# ***THE GROVES LOW TRAFFIC NEIGHBOURHOOD, YORK***

Stage 3 Road Safety Audit

Including Designer response from City of York Council (27 May 2021)

**PROJECT NO. 70053766**

Earle Street.

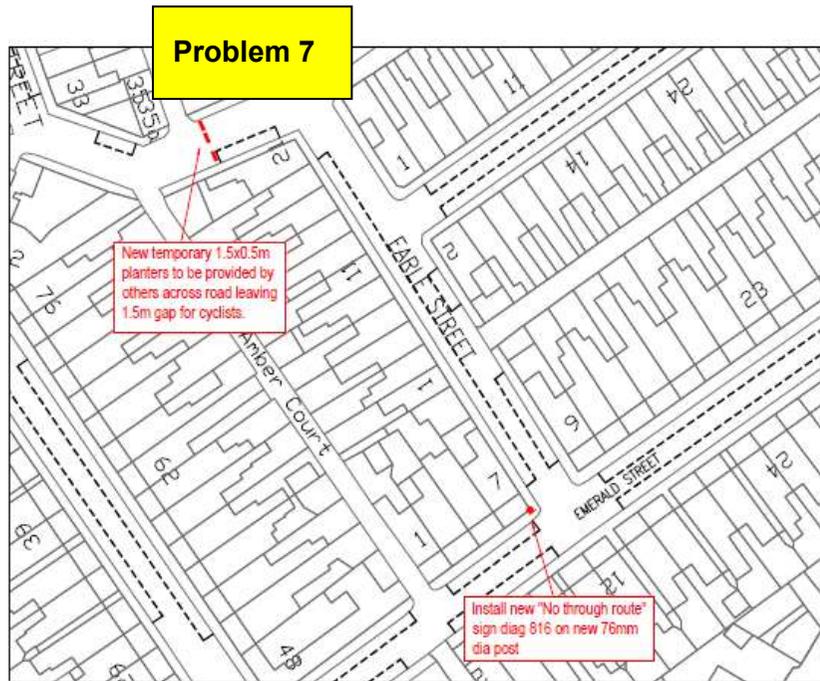
At the end of Amber Street, near number 33, where Amber Street leads into Earle Street there is no prior warning of the road closure which is made up of planters and concrete blocks. Motorists may turn the corner of Amber Street and collide with the stationary objects.

It is recommended that warning signs are provided to ensure motorists are aware of the blockade (see also problem 6).

Noted. Warning signs should be provided on both approaches.

Penleys Grove Street  
j/w Monkgate

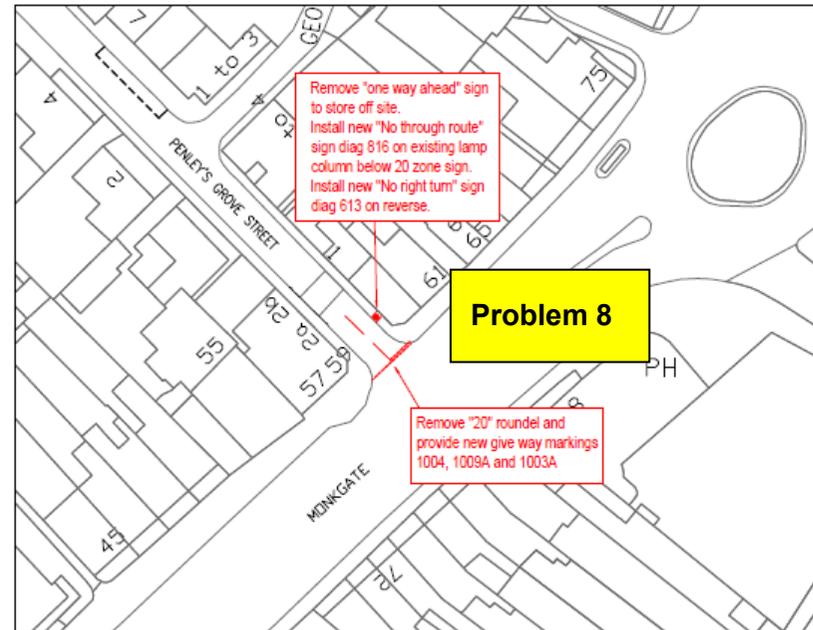
At the end of Penley's Grove Street at the junction with Monkgate, the existing 20 mph roundel has not been cleanly removed before the new road marking has been applied. Not having clear and clean road markings where a particular direction is involved could lead to vehicles misunderstanding the instruction leading to vehicles turning right into the path of other vehicles on Monkgate. This issue was more prevalent at night.

It is recommended that the redundant road markings are completely removed to avoid misperception.

Due to the nature of the temporary trial, redundant road markings were blacked out. As these markings are again showing through, they will either be blacked out again or permanently removed.
